Title		
Rocket IO & Cable Drivers		
Size	Document Number	Rev
C	DK-Technologies PT8612 HD test pattern generator	1.8
Date:	Monday, August 27, 2007	Sheet 3 of 5

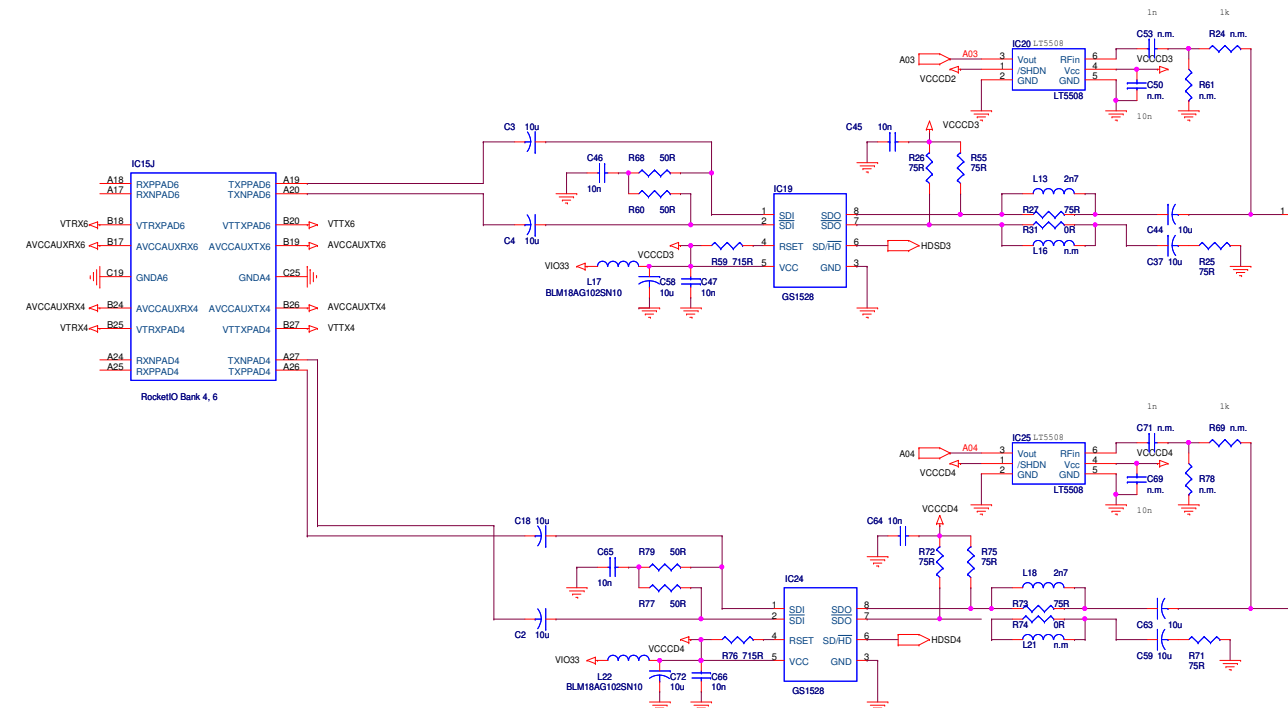
IC4, IC7, IC20, IC25 og
tilhørende modstande og
kondensator ikke monteret

Impedence of 4 output channel is changed to 75ohm
